AGAR GROVE

CONCEPT FOR RAINWATER HARVESTING ON FUTURE PHASES

Rev A 07/11/17

The DAS site plan currently shows tanks in A, FGH & JKL only, none shown in CDE:

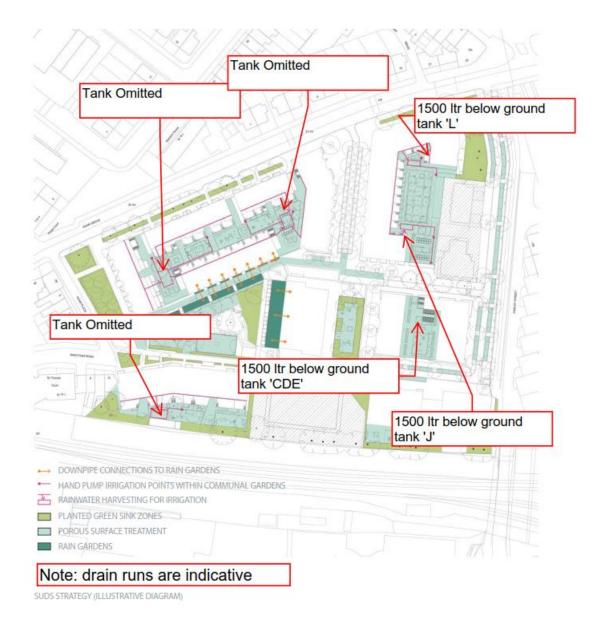
Update DAS plan to show rainwater harvesting tanks below ground in the locations and numbers shown below.

Note that tanks at A, G&H are omitted. As detailed design is already completed on these locations, it would be highly disruptive to re-introduce these at this stage. This will not affect the overall storm water attenuation, as confirmed in a statement from PBA (also see appendix):

Location	Capacity, Itrs
А	n/a
CDE	1500
G	n/a
Н	n/a
L	1500
J	1500
Total	4500

Local rainwater downpipe(s), are routed to the tank inlet. Laid to required falls; this sets the tank depth. Tank to be located within 20m of downpipe connection. Drainage directly from roof areas only- no surface level water permitted. To drain an area of at least 50m² of roof. Pipe work laid to same specification as other below ground drainage on this site- refer to PBA specification.

Provide below ground tanks of 1500 litres actual capacity, for specification refer to attached product (see appendix), or equal and approved. Inline filter and siphon with overflow to drain. Inlet connection with flow smoothing, access hatch. Provide pump chain, NB no electric pump provided. Provide outlet to connect to a hand pump. Overflow connection to storm water drainage (by others).
